# Access Compliance Report

## Public Rights-of-Way

Intersection ID: 29711	Main Street: GATESVILLE_LN	Cross Street: ROBESON_CREEK_DR	Location: S
ADA ID: EB337FC20B65	Ramp Type: PerpDiag	Initial Pass/Fail: Pass	Overall Compliance: No
			Severity Score: 10.25

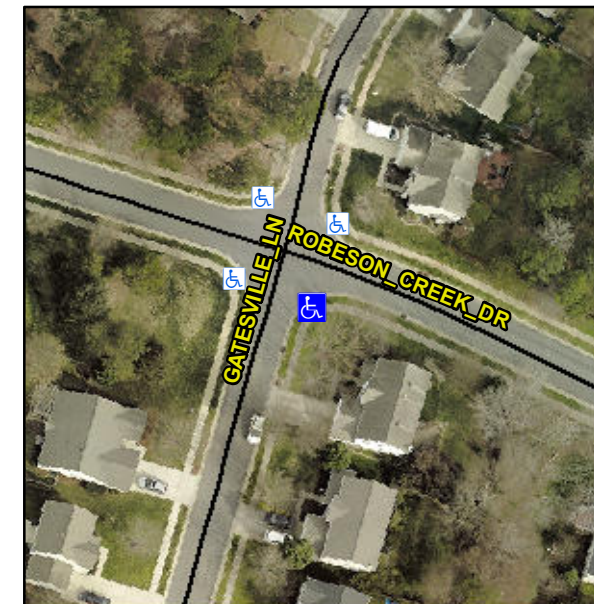
**R304.5.3, R304.2.1, R305**

Compliance	Description	Data	Compliance	Description	Data
N/A	Ramp Length (in)	48.0	Yes	Ramp Slope (%)	5.5
Yes	Ramp Width (in)	48.0	No	Ramp XSlope (%)	2.2
N/A	Flare Type LT	Sloped	N/A	Flare Type RT	N/A
N/A	Flare Slope LT (%)	2.5	N/A	Flare Slope RT (%)	6.3
N/A	Flare Traversable LT?	No	N/A	Flare Traversable RT?	No
No	Landing Length (in)	47.5	No	DWS Provided?	No
Yes	Landing Width (in)	48.0	N/A	DWS Contrast?	No
Yes	Landing Slope (%)	1.8	N/A	DWS Length (in)	N/A
Yes	Landing X Slope (%)	1.4	N/A	DWS Full Width?	No
N/A	Landing Curb? (Y/N)	No	N/A	DWS Offset (in)	N/A
N/A	Shared Landing?	No			
Yes	Gutter Ponding?	No	Yes	Gutter Slope (%)	1.6
Yes	Gutter Lip Ht (in)	0.0	Yes	Gutter X Slope (%)	1.2
N/A	Painted X Walk1?	No	N/A	Painted X Walk2?	No
	X Walk 1 Direction	To NE		X Walk 2 Direction	To NW
N/A	X Walk 1 Width (in)	N/A	N/A	X Walk 2 Width (in)	N/A
	X Walk 1 Slope (%)	2.1		X Walk 2 Slope (%)	6.8
	X Walk 1 X Slope (%)	3.4		X Walk 2 X Slope (%)	0.1

**Remove & Replace Curb Ramp With Two New Directional Ramps or Equivalent.**
